2015 Chevy Truck Silverado 1500 2WD V6-4.3L

## #18-NA-161: Steering Jerks Or Kicks Back / Reduced Power Steering Assist / Engine Stall / No Start / Service Stabilitrak / IPC / Radio / HVAC Goes Blank Various DTCs - (Oct 22, 2018)

This bulletin replaces PIT5405C. Please discard PIT5405C.

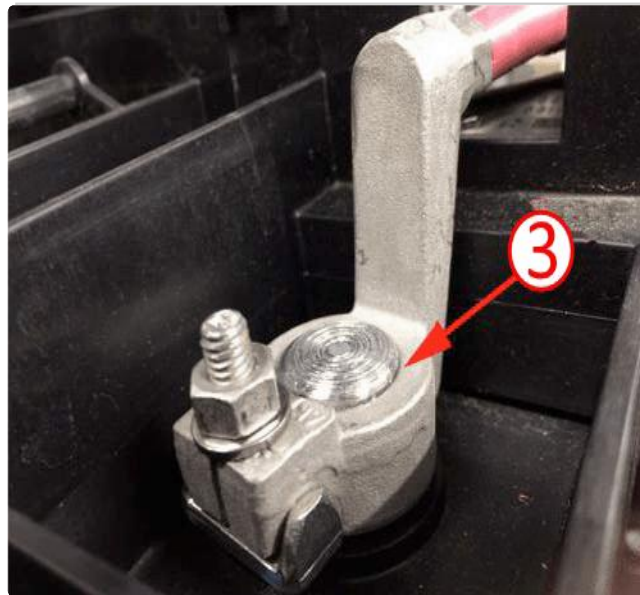
<b>Cause 2</b>	This condition may be caused by a poor BCM ground at G218.
<b>Cause 3</b>	<p>This condition may be caused by a shorted B+ Battery cable (3) at the Starter Solenoid caused by:</p> <ul style="list-style-type: none"> <li>• A loose starter shield contacting the starter battery cable terminal ring.</li> <li>• A starter cable ring terminal that has been mis-installed and/or rotated when installed on the starter solenoid.</li> </ul>
<b>Cause 4</b>	This condition may be caused by a discharged or faulty battery.
<b>Correction 1</b>	<p><b>Important:</b> The following steps must be completed in order. Grasping or attempting to rotate cables could affect readings and should be done <b>after</b> performing the voltage drop measurement.</p> <p><b>Note:</b> When checking voltage drop, the voltage drop should be performed with the fuel system disabled (or hold the accelerator WOT) and while cranking the engine. MIN/MAX on the Digital Multi Meter (DMM) should NOT be used. The voltage drop should be monitored at a STEADY crank. Inspect for any high resistance and/or loose connections at both the battery fuse block and the positive or negative battery cables.</p> <div data-bbox="613 968 1252 1556" data-label="Image"> </div> <div data-bbox="623 1562 1068 1608" data-label="Text"> <p><a href="#">Open In New Tab</a> <a href="#">Zoom/Print</a></p> </div> <ol style="list-style-type: none"> <li>1. Perform a loaded voltage drop test on the short positive battery cable (1). <ul style="list-style-type: none"> <li>◦ Refer to “Measuring Voltage Drop” in SI. If the voltage drop is above 100 mV, replace the affected cable(s).</li> <li>◦ For positive cable parts information, refer to the Parts Information section.</li> </ul> </li> </ol>

Inspect G218 (applies LD Trucks and SUVs built prior to June 2015):

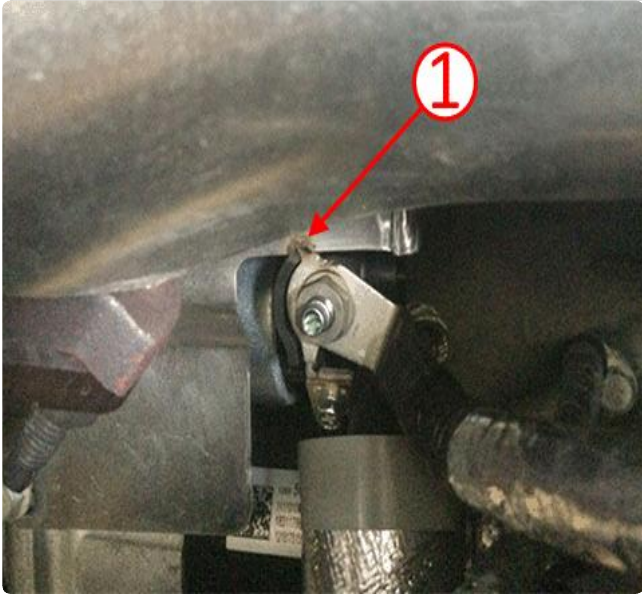
- Check for the nut being loose or cross threaded (1), repair and tighten as necessary.

- Check for the front of dash insulator mat (2) being trapped between the ground eyelet and the body/stud as shown.
  - If the dash insulator mat is trapped, cut the mat away from the ground stud so it will no longer interfere. Reinstall the ground eyelet, the nut, and retighten.
